Application No.: 10/812,447

Docket No.: JCLA10877

Annotated Marked-up drawing

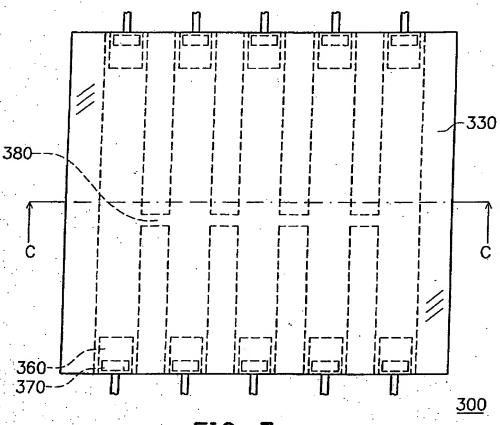
The drawings are objected to as failing to comply with 37 CFR 1.84(p)(5) because they include the following reference character not mentioned in the description: figure 8, item 304.

In response thereto, applicants correct item 304 in Fig.8 to be "item 340" because the reference numeral 304 is a typographical error of the reference numeral 340.
